SKILLING, HELLE, CHRISTIANSEN, ROBERTSON — Structural & Civil Engineers

PROJECT: THE WORLD TRADE CENTER | TITLE: REVISED BEAM CONN. TO SLURRY WALL - DETAIL H | DATE: 6-20-69

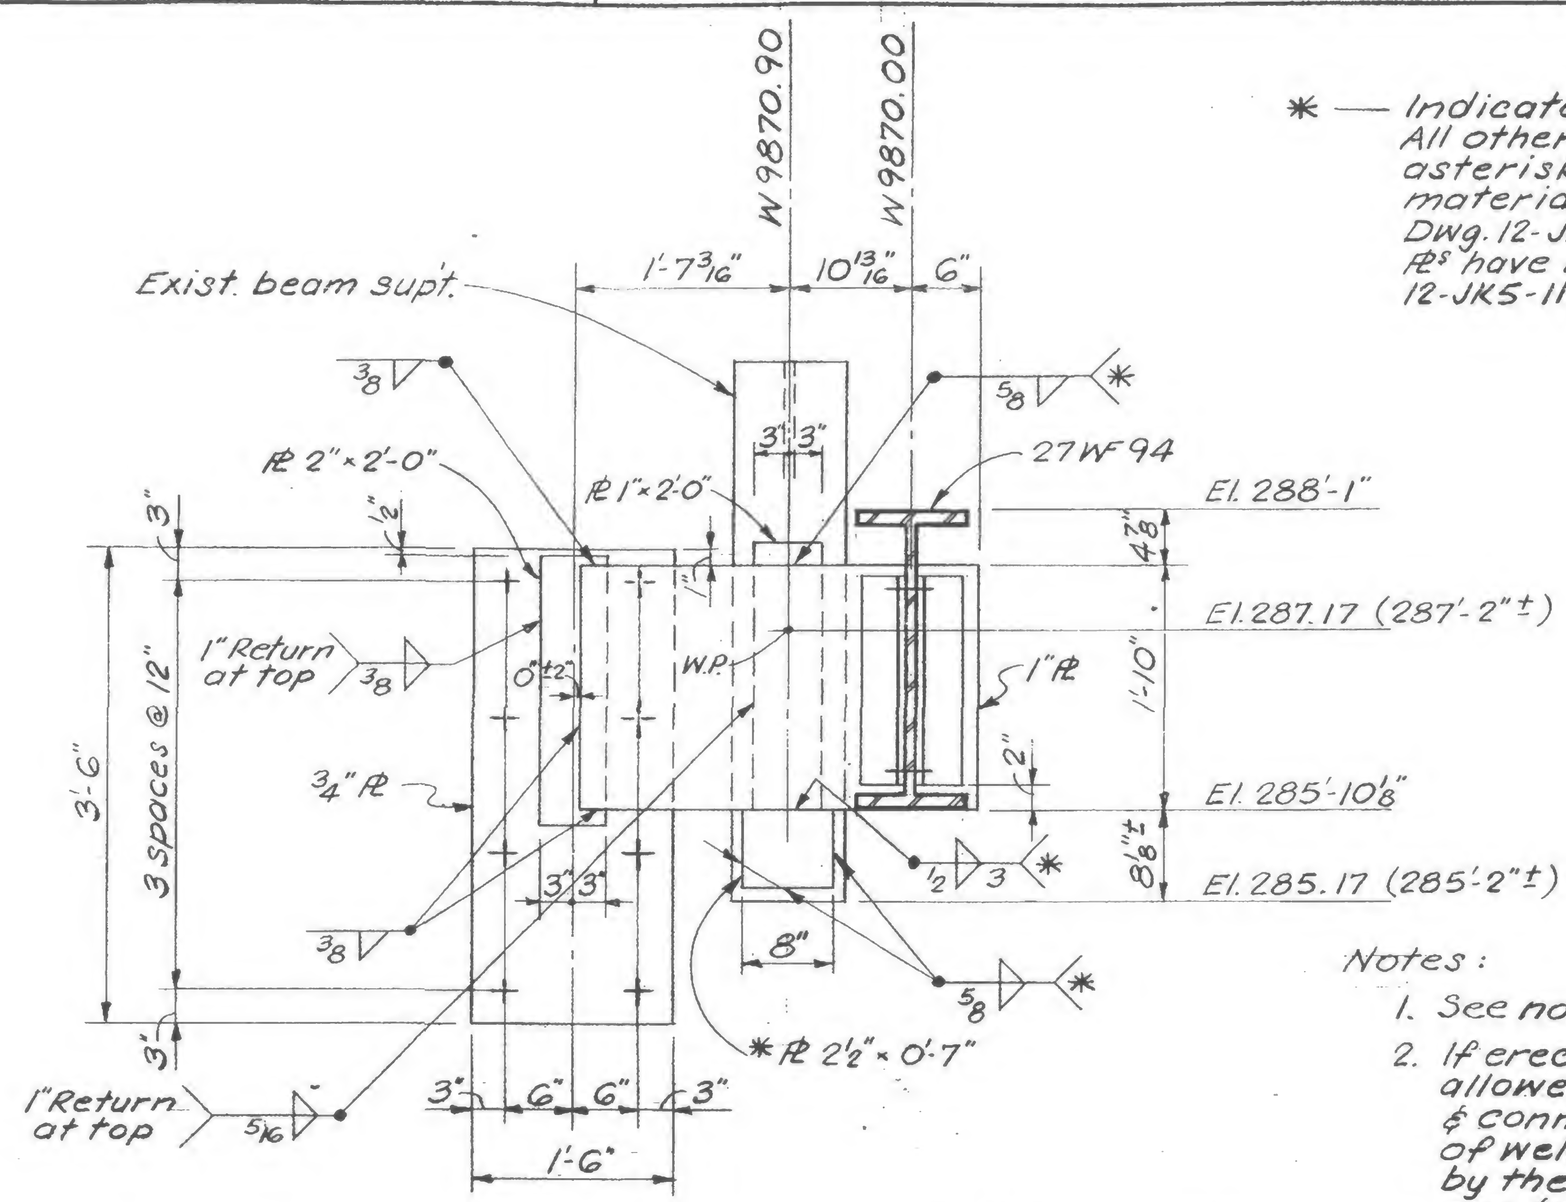
* — Indicates new PL and welds. All other items without asterisk, are existing materials as shown on Dwg. 12-JK5-11 (location of PLs have been revised from 12-JK5-11)

1. See notes on 12-JK5-1.
2. If erection clearance is allowed between beam web & connection angles, size of weld has to be increased by the dimension of this gap (max. clearance = 1/8").
3. Due to the deviation of exist. beam support, the weld size shown has to be increased by the dimensions of the gap between PL and support. In no case should this gap be greater than 1/8".
